Document under Review: **P802.16e/D6**Ballot Number: **0001010**

Part 16: Air Interface for Fixed and Mobile Broadband Wireless Access Systems
 Amendment for Physical and Medium Access Control Layers for Combined Fixed
 and Mobile Operation in Licensed Bands
 2005 February 22

Comment Type **Technical, Binding**Starting Page # **220** Starting Line # **6**Fig/Table# **251a** Section **8.3.6.3.9**

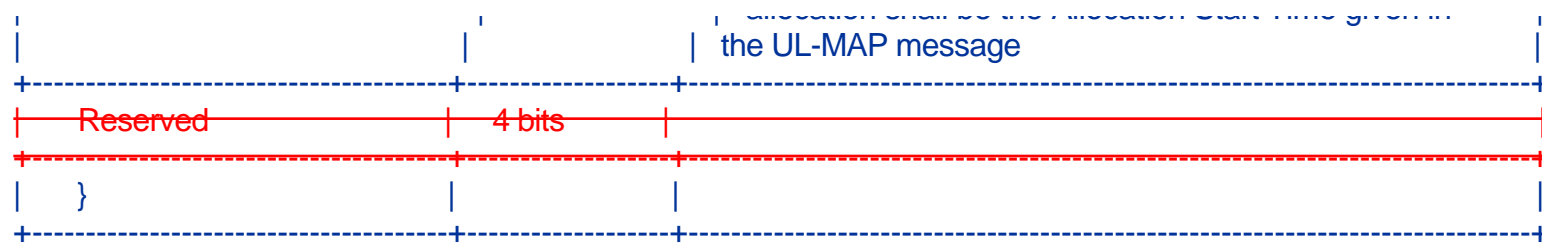
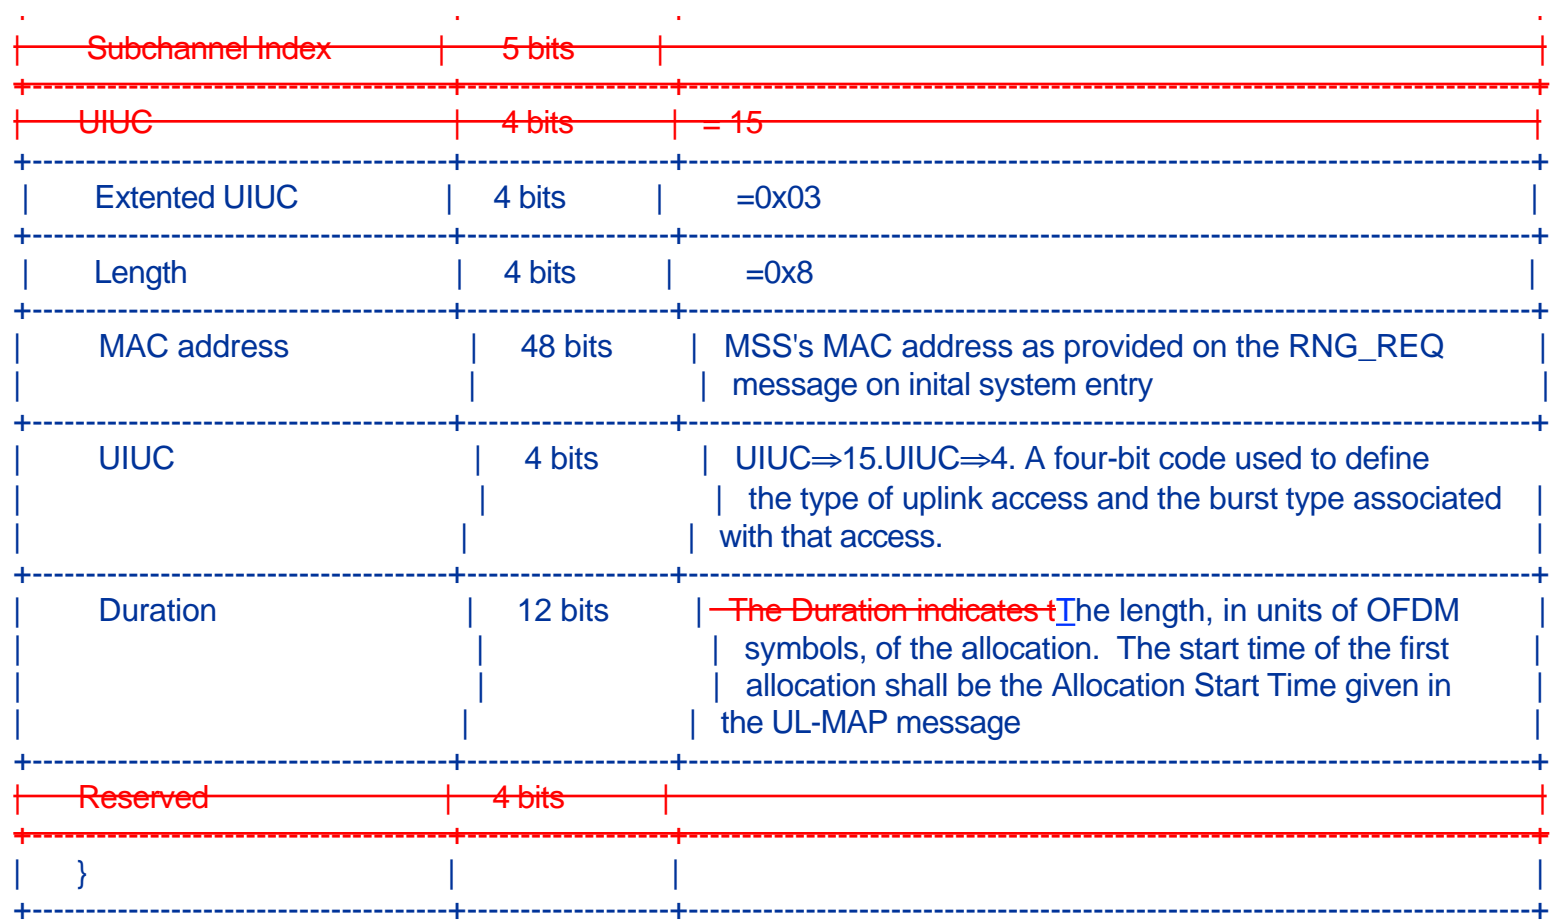
I object to the implementation of Comment 1068 in IEEE 802.16-04/69r4, because not all the changes were implemented. In addition the changes do not fix the entire table (an issue I raised in a reply comment to Rainer's original comment).

The Fast Ranging Information Element (Table 251a) does not conform to the OFDM-256 UL-MAP extended IE format (Table 249 in 8.3.6.3.4 of 802.16-2004), where the first field must be the Extended UIUC field of 4 bits followed by the Length field of 4 bits. In Table 251a, the fields for CID, Start time, Subchannel index, and UIUC are not supposed to be present as these parameters are in the generic UL-MAP IE as shown in 802.16-2004, Table 245, on p. 467.

On page 220, make the following changes to Table 251a:

Syntax	Size	Notes
Fast_UL_ranging_IE {		
CID	16 bits	- initial ranging 0x0000
Start time	11 bits
